# Errata for 2018 Uniform Plumbing Code Illustrated Training Manual – 2nd Printing

The following are changes that we found after the second printing of the *2018 Uniform Plumbing Code Illustrated Training Manual*. These changes may apply to your code book. Thank you.

**FIGURE 310.1  
PROHIBITED OR RESTRICTED FITTINGS**

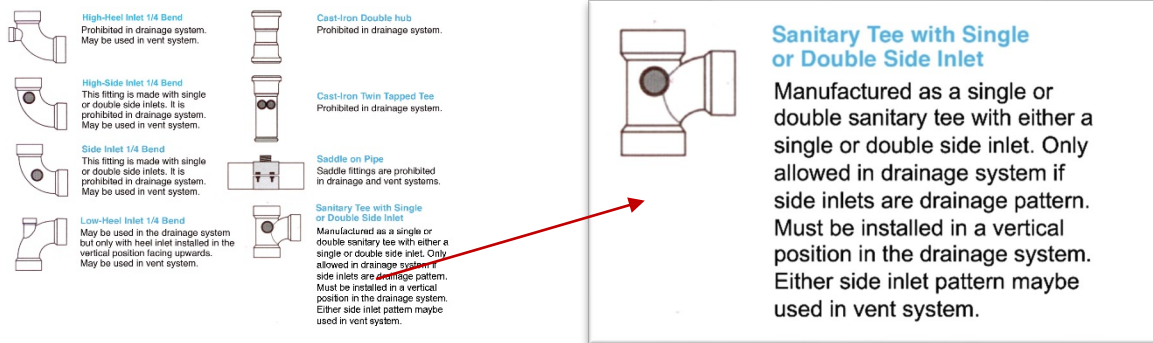
Figure 310.1 Prohibited or Restricted Fittings – The commentary in the figure for “Sanitary Tee with Single or Double Side Inlet” should be corrected as follows:

Manufactured as single or double sanitary tee with ~~we~~ither single or double inlet. ~~Prohibited in drainage system if side inlets are straight pattern. Only a~~Allowed in drainage system if side inlets are drainage pattern. Must be installed in a vertical position in the drainage system. Either side inlet patterns may be used in vent system.
